Wizards Workshop

TEKTRONIX INTERNAL USE ONLY

April 4, 1980
Issue 10-7

4633A MOD JE: MAINBOARD DEFLECTION AMPLIFIER CHANGE

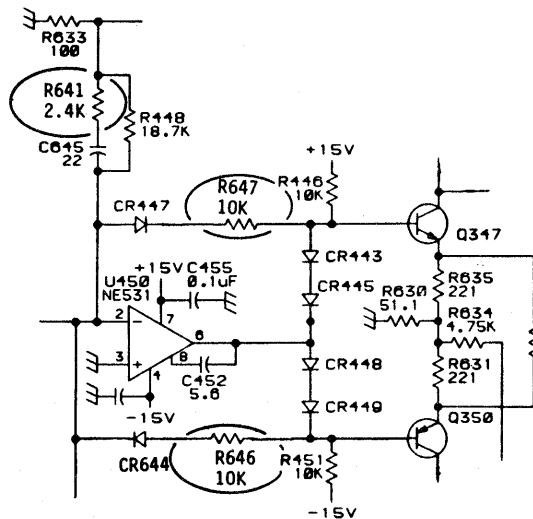
The 4633A Mod JE x-axis deflection amplifier has been known to break into a one megahertz (1 MHz) sawtooth oscillation. The tendency to oscillate has been best displayed when the CRT trace is not centered on the faceplate. The cause of oscillation lies in the fact that during retrace, when either CR447 or CR644 are on, the feedback is unity. U450, however, is not compensated for unity feedback.

To prevent this oscillation, 10K Ω resistors are installed in series with CR447 and CR644 to attenuate feedback during retrace. In addition, R641 is changed in value from 15K Ω to 2.4K Ω (see schematic).

<u>CIRCUIT NUMBER</u>	<u>OLD VALUE</u>	<u>NEW VALUE</u>	<u>NEW PART NUMBER</u>
R641	15K	2.4K	315-0242-00
R646	-	10K	315-0103-00
R647	-	10K	315-0103-00

Installation of this modification causes the mainboard part number to change from CM670-6394-00 to CM670-6394-01.

S-3200 SYSTEMS: CONSOLE TERMINAL HANGS UP

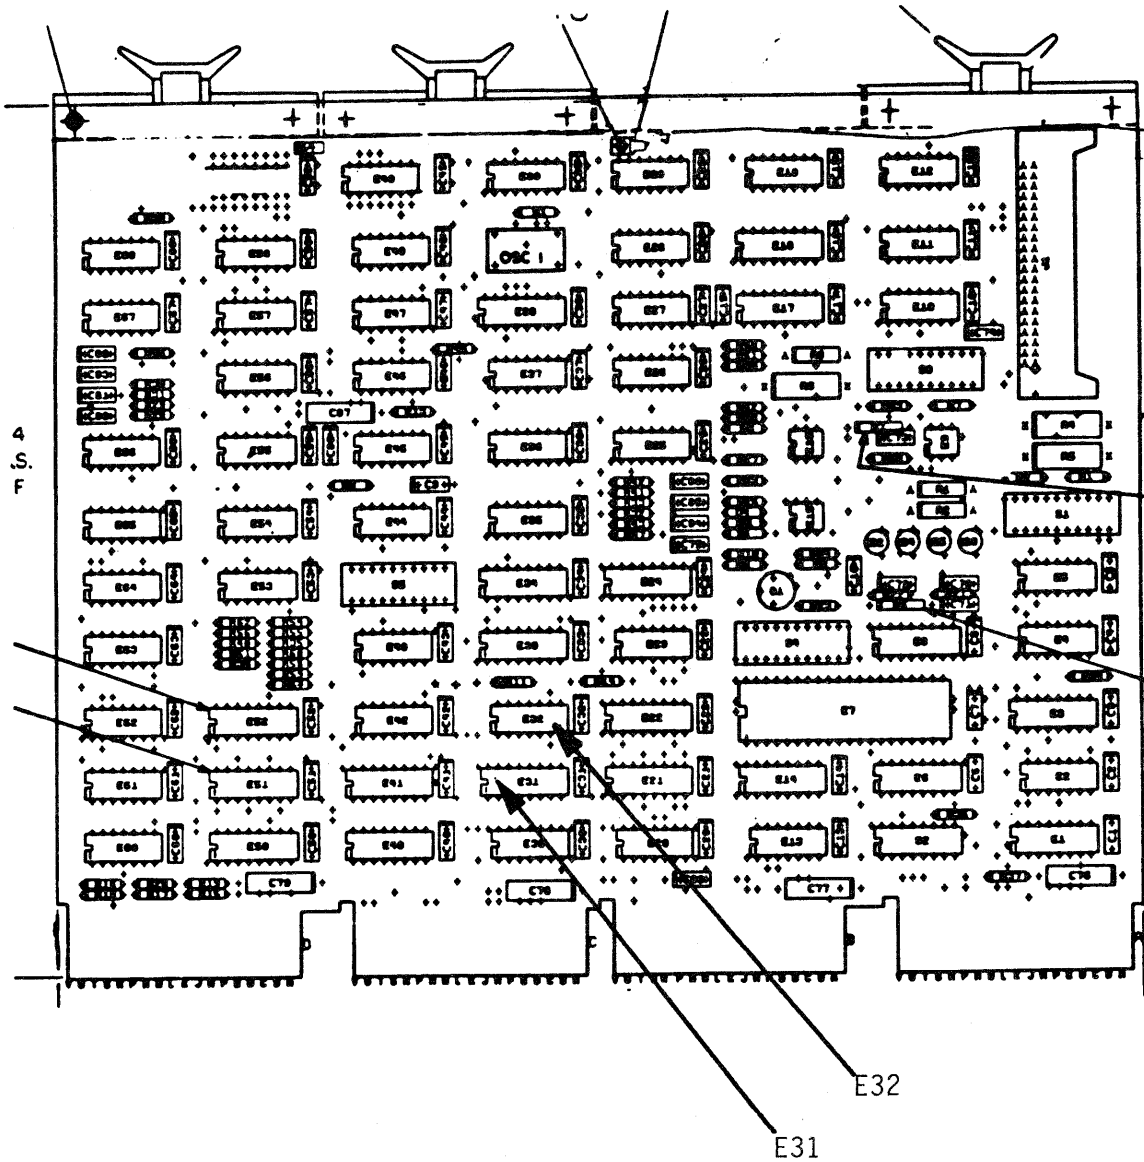
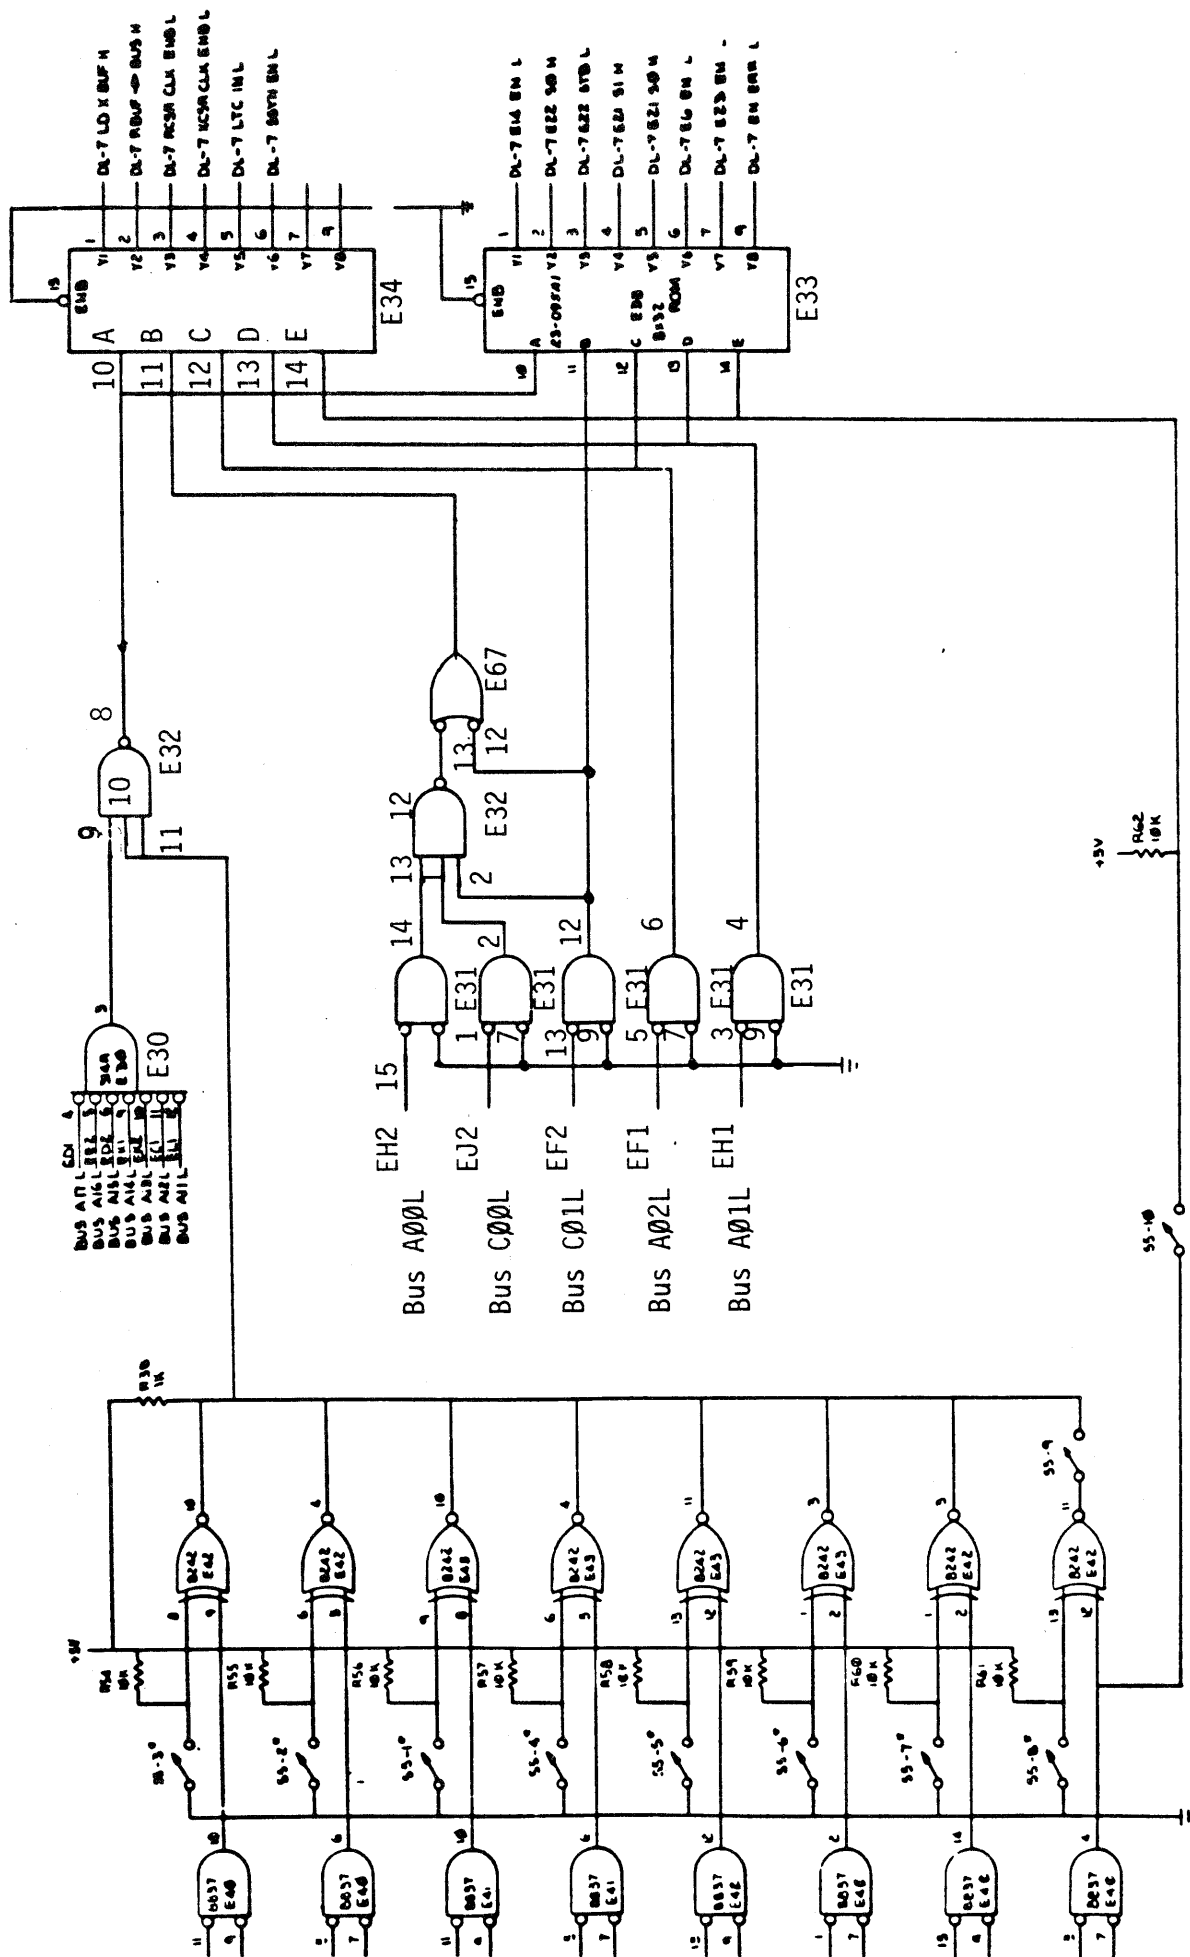
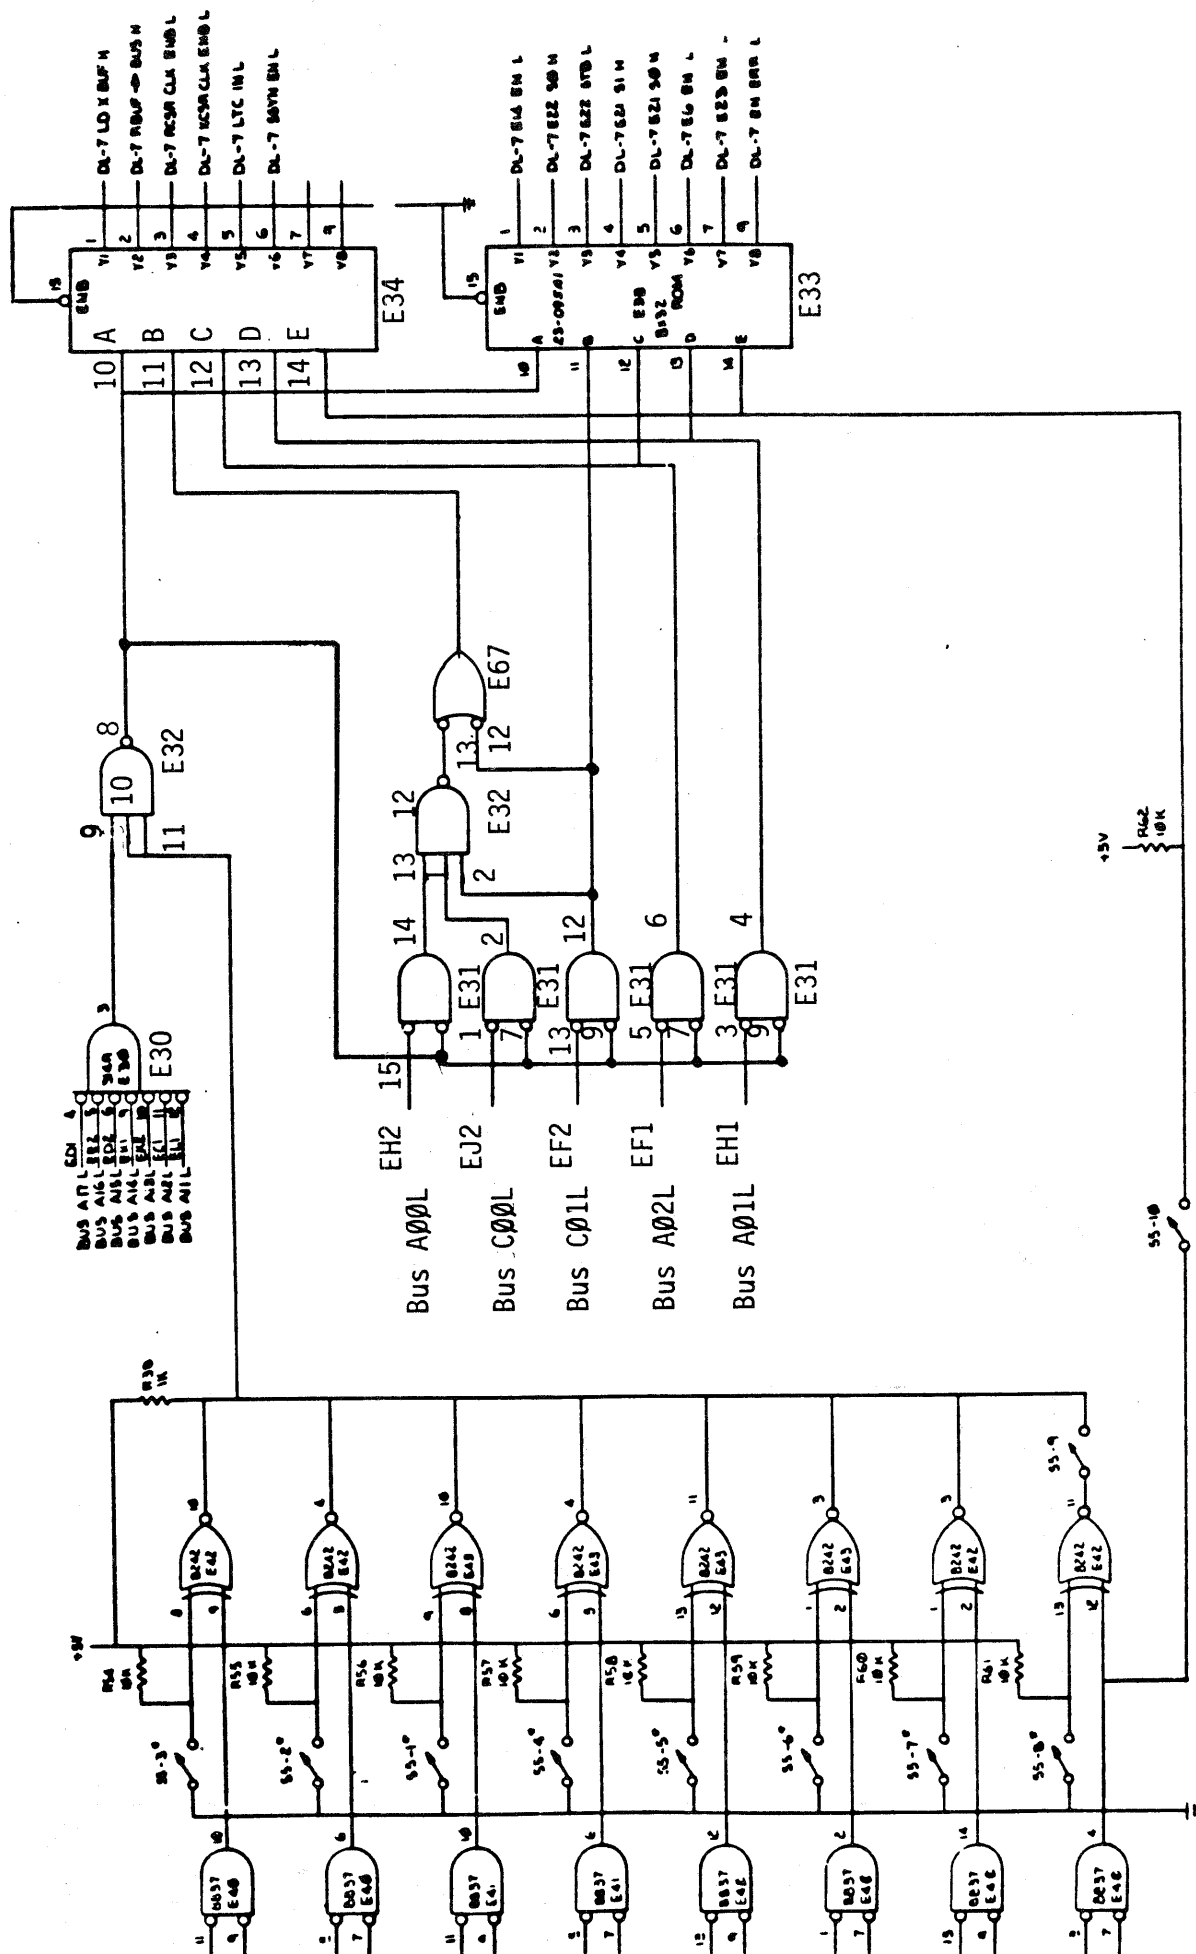
Drops INTR ENABLE (Rec and Xmit) caused by Rom E34. The Rom output is always enabled, thus the address lines on the Rom Change with the unibus address lines, causing spikes to appear on the output of the Rom.

The spike on Pin 3, E34, RCSR CLK ENB L on DL-7 gets anded with MSYNL on Pins 11 and 12 of E23 (DL-4), result is DL-4 RCSR CLK H. This signal clocks the RCVR ENTR F/F ON DL-1 E37 Pin 3, being there is no data on Pin 6 at the time, the F/F gets cleared, dropping the enable.

Due to the confusion experienced with D.E.C. method, the following procedure is recommended.

1. Side 1, Lift legs 7 and 9 of E31
2. Connect legs 7 and 9 of E31 to leg 8 of E32 using small insulated wire.
